11416, 11420, 11419 and 11423 - 78 Avenue NW

To allow for two transit oriented mid-rise residential buildings with limited commercial uses fronting on public open spaces.

The application retains much of the existing initial proposal considered by City Council on September 13, 2022 including building placement, design themes and community contributions. However, minor adjustments have been made to the DC2 Provisions and Appendices have been incorporated to reflect the reduced land assembly of the redevelopment site by refining the street wall interface and amenity areas along the Green Spine and rear facade for better integration with surrounding areas and building efficiencies. A markup of changes to the DC2 can be found in Appendix 1 of this report.

Waste Services

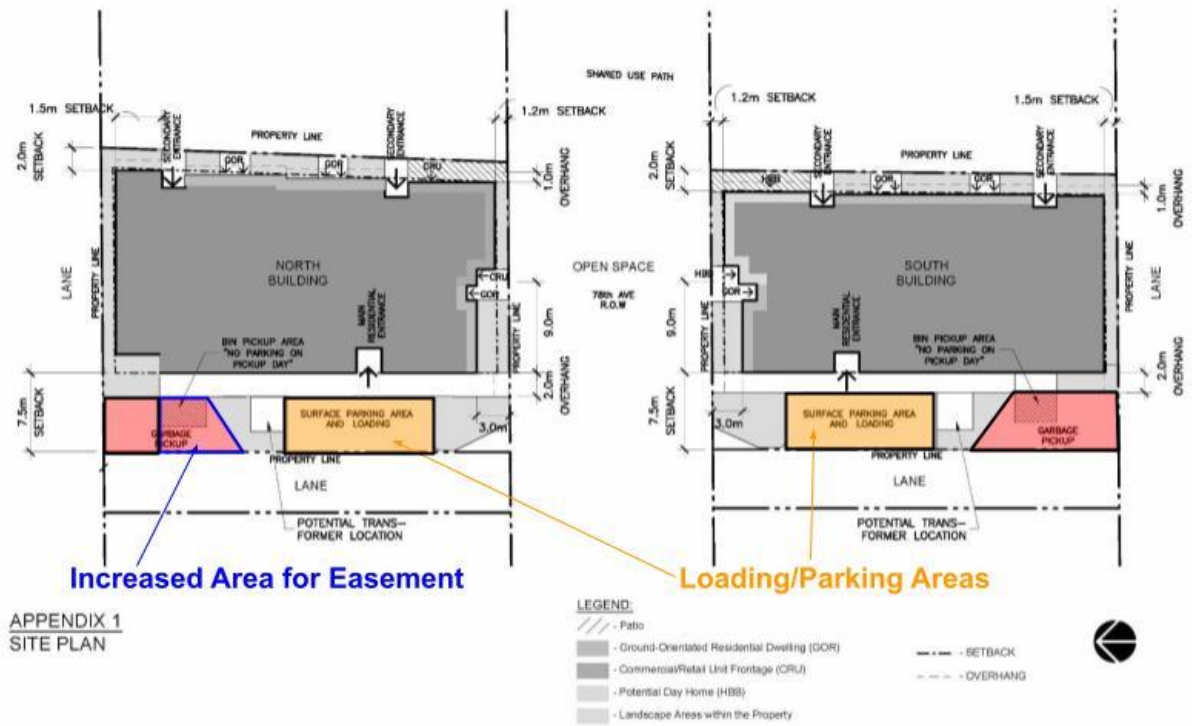
The revised application includes reconfiguration of the loading space, easement and waste collection areas on the west side of the site (see image below).

The loading zones for both buildings have been removed from the easement areas, thus reducing potential turning conflicts for waste servicing vehicles. To accommodate this change, loading space areas have been relocated to the surface parking areas for the purposes of both loading and parking needs.

The easement area for the north building has been expanded to the south. This creates additional manoeuvring turns for waste collection trucks and allows for potential gains in efficiency when collection routes are planned. To ensure turning movements, a condition of the easement agreement requires the waste collection and easement areas to be clear of any obstructions and the DC2 provisions now includes requirements for site signage denoting no parking or loading allowed within these areas. The easement areas for both buildings shall be registered on title for the subject properties as a condition for the road closures.
